NEW GEN & DUAL LEAD COMPATIBILITY MODIFICATION

READ INSTRUCTIONS COMPLETELY PRIOR TO STARTING

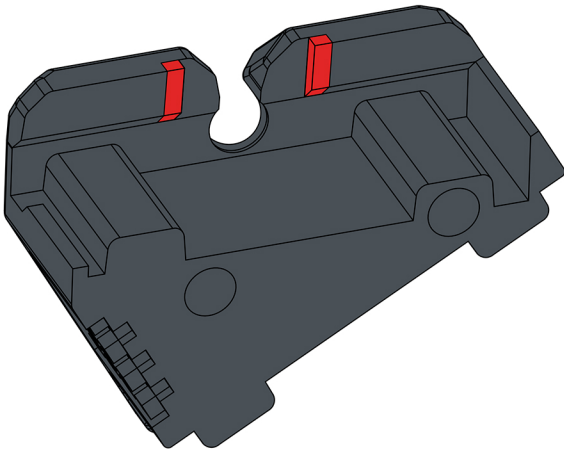
- 2** LOCATING THE MATING TABS ON THE RAMP OR DUAL RAMP PRODUCT AND REMOVE 0.05" (ROUGHLY THE THICKNESS OF A PENNY) OF MATERIAL FROM EACH SIDE AS SHOWN HIGHLIGHTED IN RED. DOUBLE CHECK FITMENT WITH YOUR NEW GENERATION MODBUTTON LITE TO CONFIRM THE AMOUNT OF MATERIAL REMOVED IS CORRECT. THE MODBUTTON LITE TABS SHOULD HAVE A SNUG FIT IN THE RAMP.

- 3** THIS MODIFICATION IS ONLY REQUIRED FOR DUAL LEAD MODBUTTON LITES.

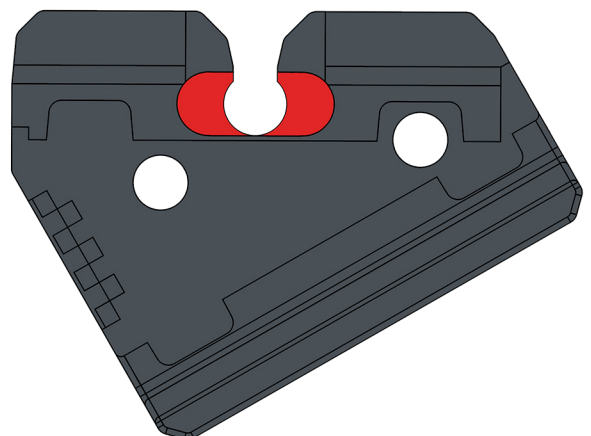
USING A $\frac{5}{32}$ " DRILL BIT, DREMEL BIT OR RAT TAIL FILE, REMOVE MATERIAL LEFT AND RIGHT OF THE EXISTING CABLE CHANNEL AS SHOWN HIGHLIGHTED IN RED. AMOUNT OF MATERIAL REMOVED FROM EACH SIDE IS 0.12" (ROUGHLY THE THICKNESS OF TWO PENNIES). TEST FIT BY GUIDING EACH WIRE SEPARATELY INTO THE NEW CHANNEL AND ENSURE WIRES ARE NOT TIGHT OR SQUISHED TOGETHER.
